ADDENDUM NO. 4  
TO THE CONTRACT DOCUMENTS FOR  
ALDER CREEK WATER TREATMENT PLANT UPGRADES PROJECT

CITY OF SANDY

This addendum, issued on the **8th day of January 2026**, affects the request for proposal documents for the **Alder Creek Water Treatment Plant Upgrades Project** and shall be deemed an integral part of the above referenced documents.

DRAWN: ELK	CHECK: CM
VERIFY SCALE: Scales based on 22"x34" prints.	
 1-1/2 Inches	
PROJECT NO.	PAGE
224100-000	207
SHEET NO.	
F-601-D

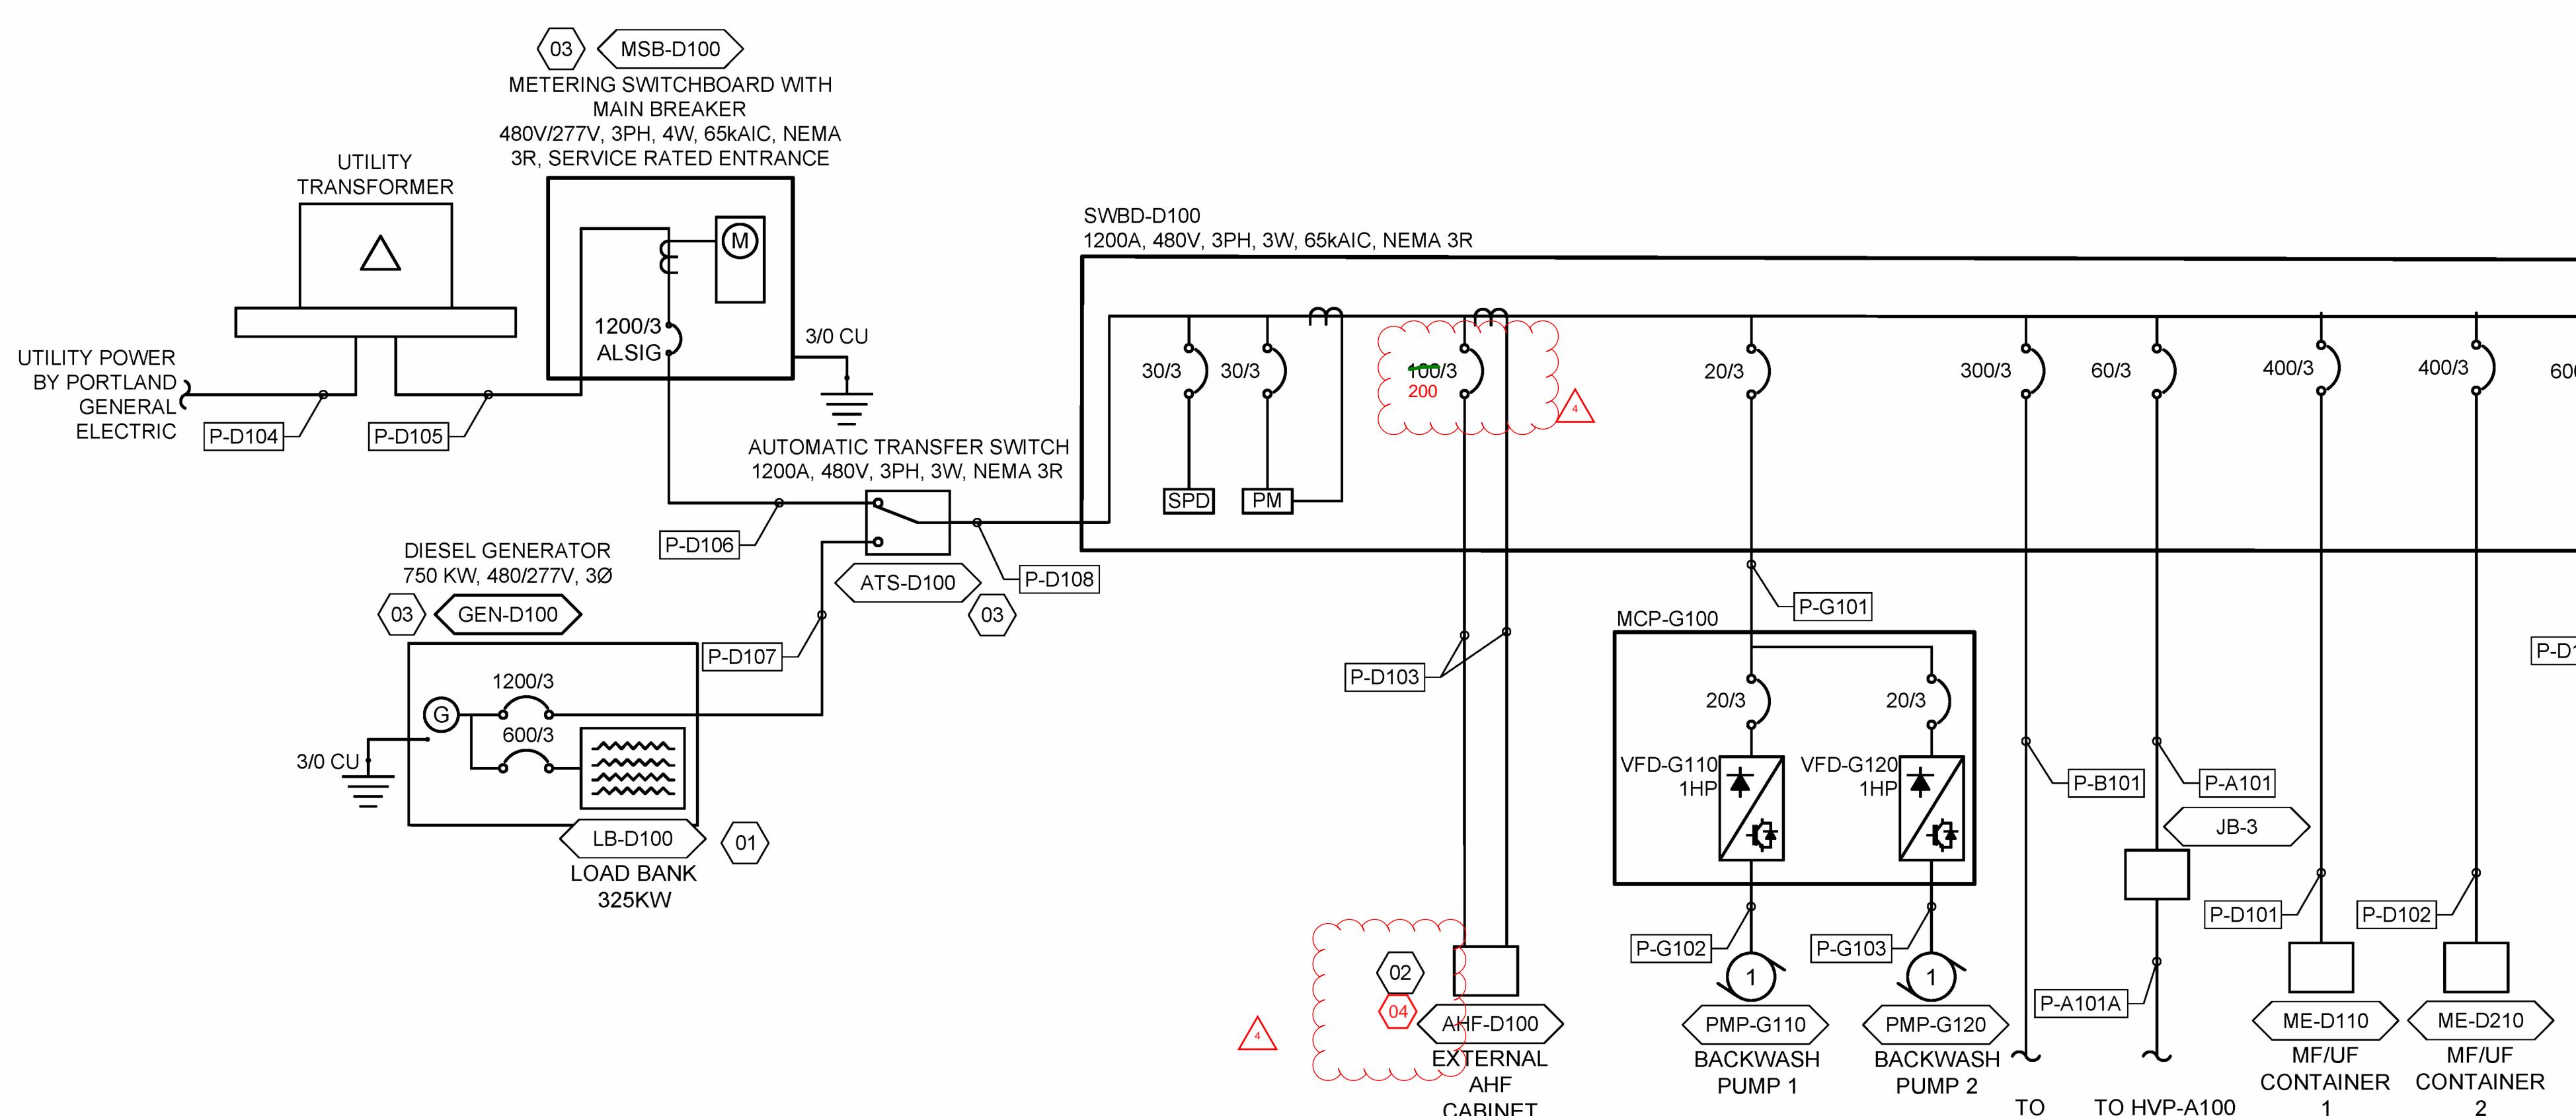
- Replace Sheet **E-601-D** with the Attached Sheet, **E-601-D**.
- Replace Sheet **E-601** with the Attached Sheet, **E-601**.

- 01 PROVIDE LOAD BANK INTEGRAL TO GENERATOR. SHALL BE FACTORY WIRED TO GENERATOR AND MOUNTED TO GENERATOR ENCLOSURE.
- 02 PROVIDE FREE STANDING ACTIVE HARMONIC FILTER, AHF SHALL BE 480VAC, 3-PHASE, 800A RATED, NEMA 1 ENCLOSURE.  
150
- 03 OWNER PREPURCHASE EQUIPMENT, CONTRACTOR INSTALLED.
